DuBois House Plan
11490 Owl Place
Peyton, CO 80831
Architectural Floor Plan

DISAPPROVED
 08/11/2020 4:00:09 PM
 Ibbett
 CONSTRUCTION

TITLE: RESIDENCE ROOF FRAMING PLAN LOT 5, FALCON RANCHETTES (11490 OWL PLACE) EL PASO COUNTY (PEYTON), COLORADO

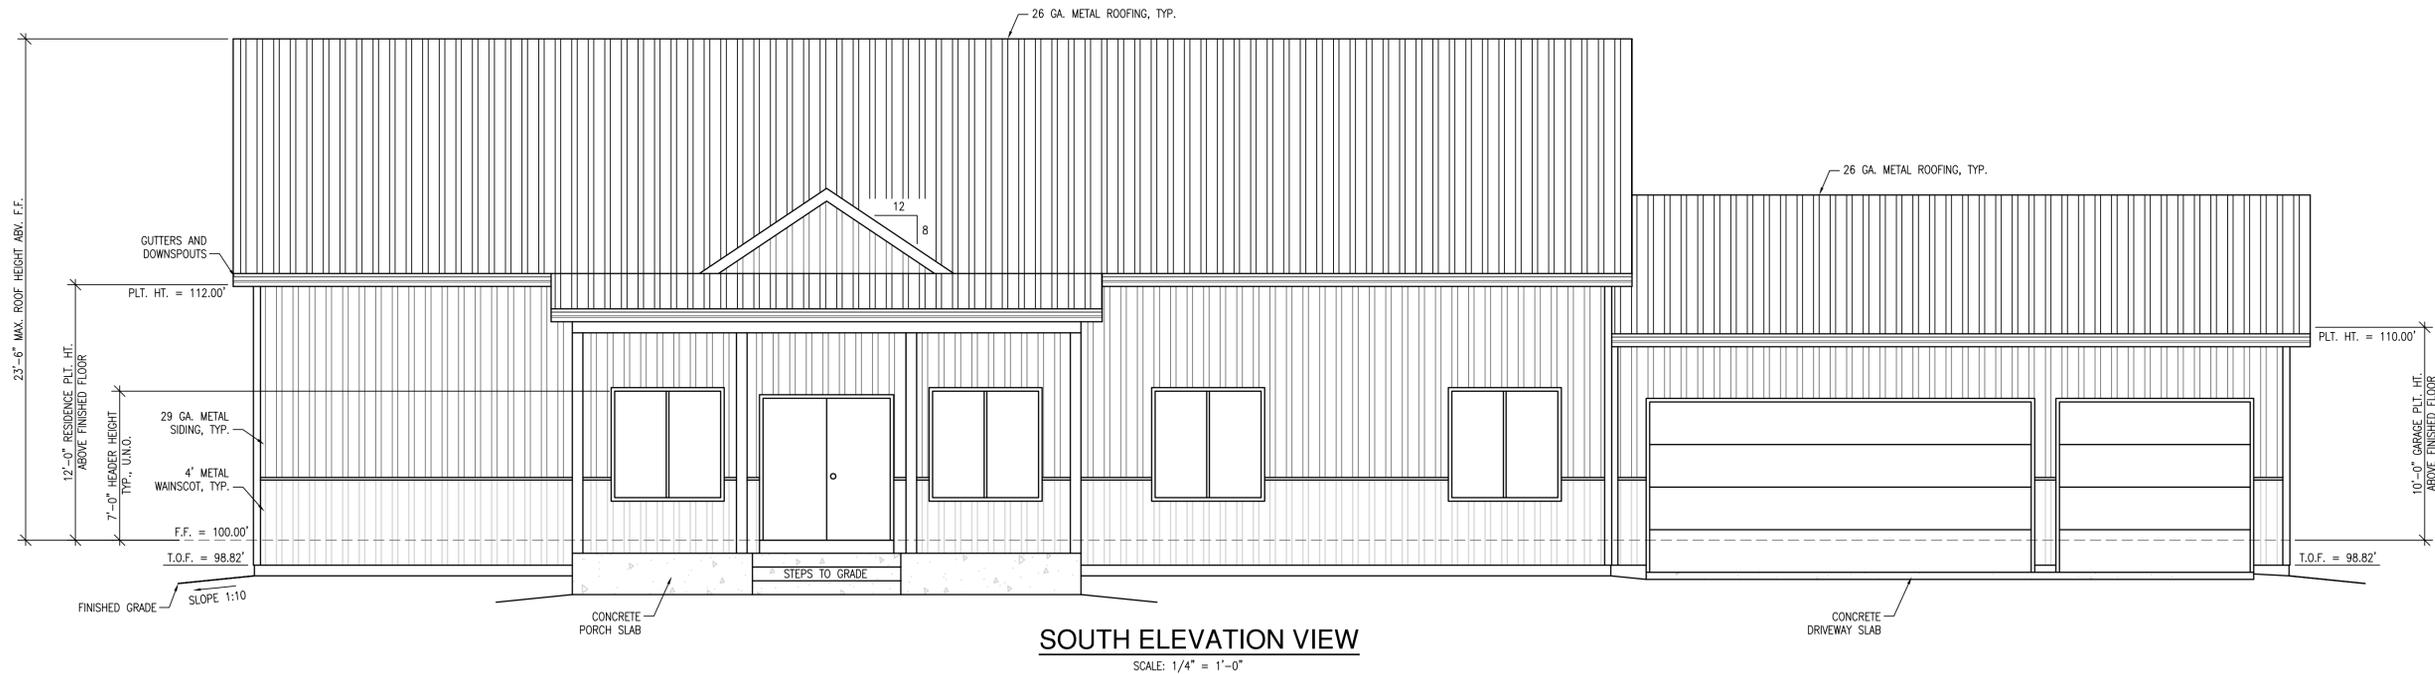
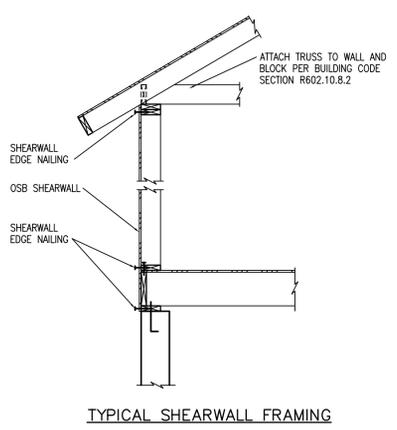
FRAMING ENGINEER MUST SPECIFY UPLIFT CONNECTORS

TYP. BUILDING SECTION
SCALE: 1/4" = 1'-0"

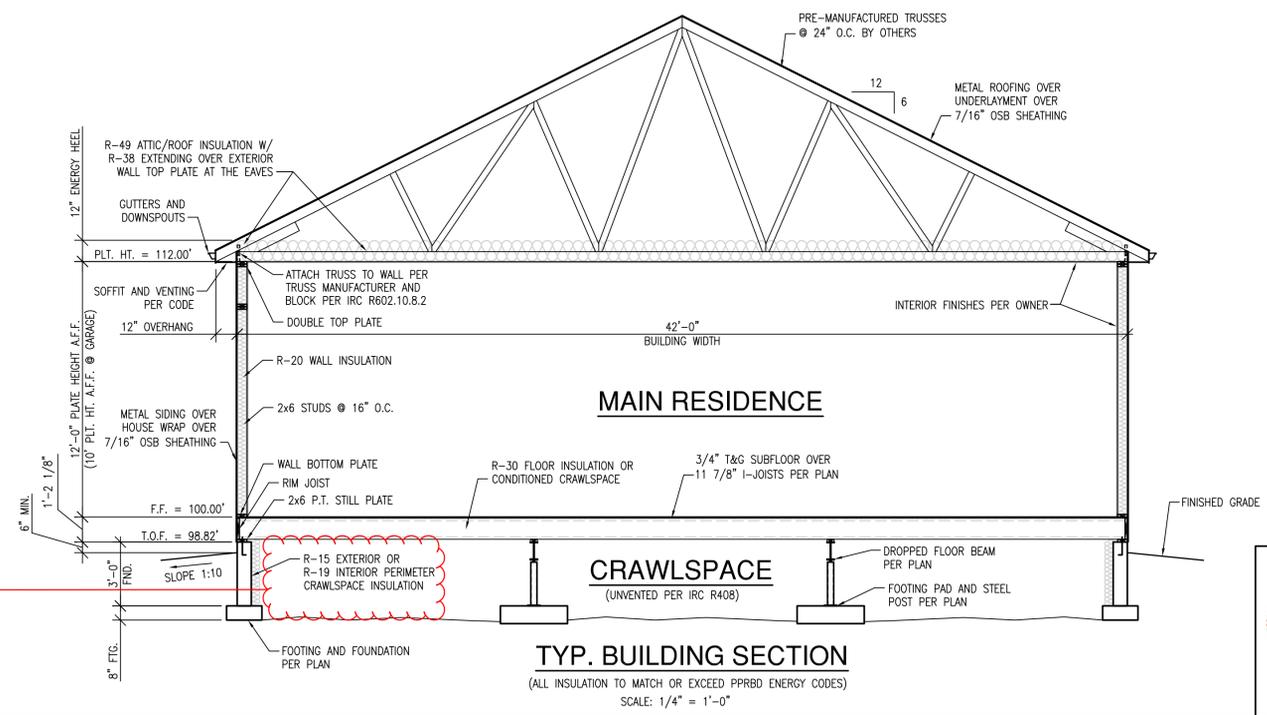
CLARIFY WHETHER CRAWLSPACE WILL BE CONDITIONED OR VENTED

SPECIFY UPLIFT CONNECTORS ON FRAMING PLAN

CLARIFY CRAWLSPACE INSULATION - NEEDS TO MATCH IECC - 15/19 = R-15 CONTINUOUS OR R-19 CAVITY
